TMC SPECIFICATION

NO. S 1108

MODIFICATION FOR RTTD-1 AND RTTD-2

TITLE: KIT-297 MODIFICATION FOR RTTD-1 AND RTTD-2

FIGURE #1

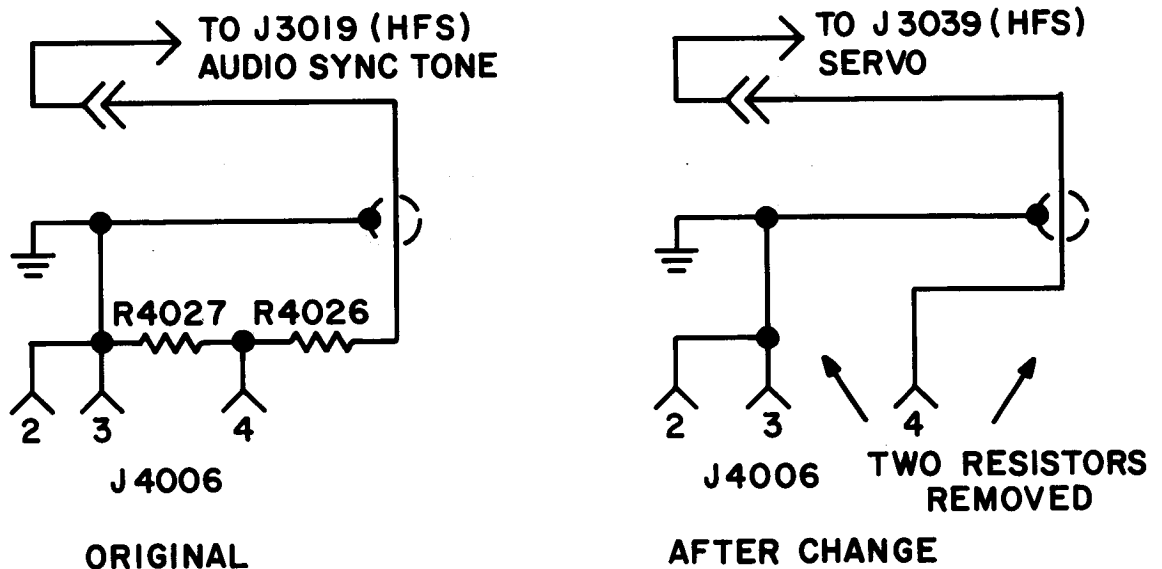
- A. At the RTTD remove R4026 and R4027 from standoffs located near J4006.
- B. Next, change AUDIO SYNC tone coax center conductor as indicated on Figure #1.

FIGURE #2

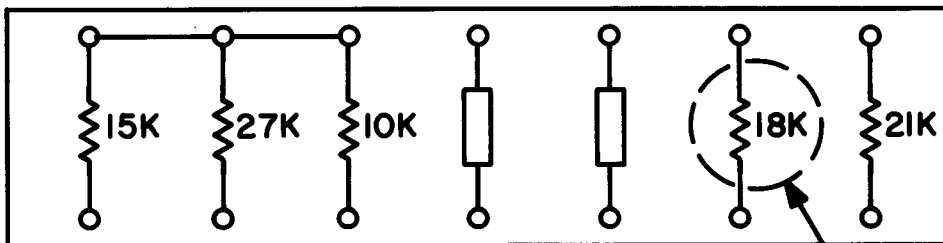
- E. Remove capacitor(s) (nominally 33uf) from between standoff.
- F. Your attention is now invited to the interior terminal board with components as shown below in Figure #2. Remove 18K (nominal).

**REMOVE BY CLIPPING LEADS**

- G. Now, remove the 18K resistor by clipping off the leads close to standoffs.
- H. On K2 relay connections, remove yellow wire pair from Pin 4 and connect yellow wire pair to standoff with grey wire pair attached. Solder a length of black insulated wire from the vacated Pin 4 to ground terminal standoff in center of box.
- I. Next, replace AZ-103 module 311 with new module 321. Fasten in place with appropriate screws. Re-install in RTTD.
